**CONTRACTOR'S SUBMITTAL TRANSMITTAL**  
LANTDIV NORFOLK 4-4355/3 (Rev. 11-80)

CONTRACT NO. 85-C-5142	TRANSMITTAL NO. 14	DATE 08/26/87
---------------------------	-----------------------	------------------

PROJECT TITLE AND LOCATION  
BACHELOR ENLISTED QUARTERS  
MARINE CORPS BASE, CAMP LEJEUNE, NC 28542  
PROJECT 627 & PROJECT 721

ITEM NO.	PROJ. SPEC. SECT. & PARA. and/or PROJ. DWG. NO. *	ITEM IDENTIFICATION (Type, size, model no., Mfg. name, dwg. or brochure number)	NO. OF COPIES	ACTION CODES **	REVIEWER'S INITIALS CODE AND DATE
	02200	EARTHWORK			
P721 4a	2.1.2	FILL, BACKFILL, STRUCTURAL FILL	1	A	HRO 8/26/87
P721 4c	2.2	POROUS FILL			
P627 6a	2.1.2	FILL & BACKFILL			
P627 6b	2.1.4	SELECT MATERIAL			
P627 6c	2.2	POROUS FILL

LOCATION OF PROJECT MCB CLNC SAMPLE NO. 4-A

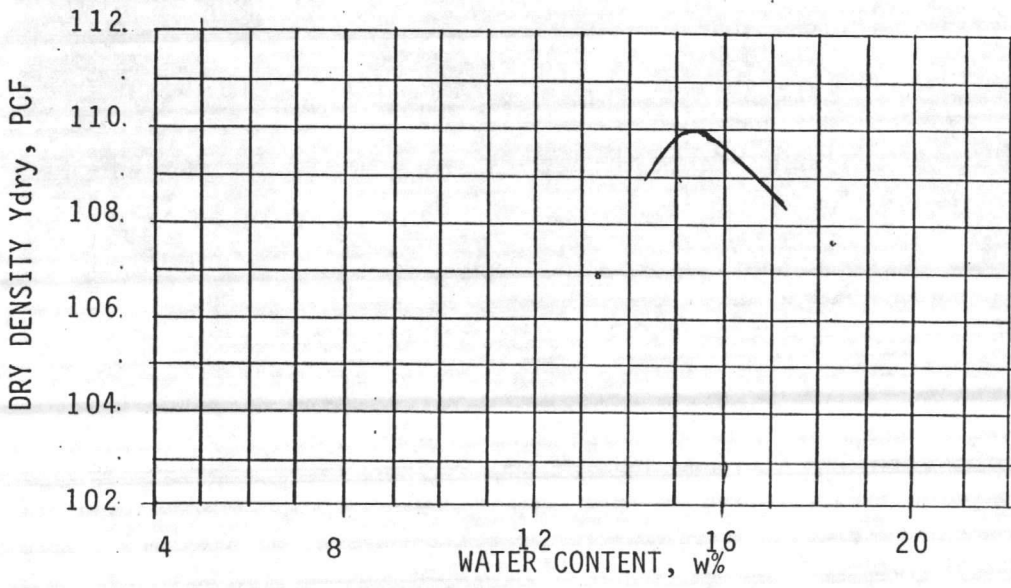
REVIEWER'S COMMENTS: **RA NOTE SAMPLE 4A DOES NOT CONFORM TO THE PROJECT SPECIFICATIONS**

DOES NOT CONFORM
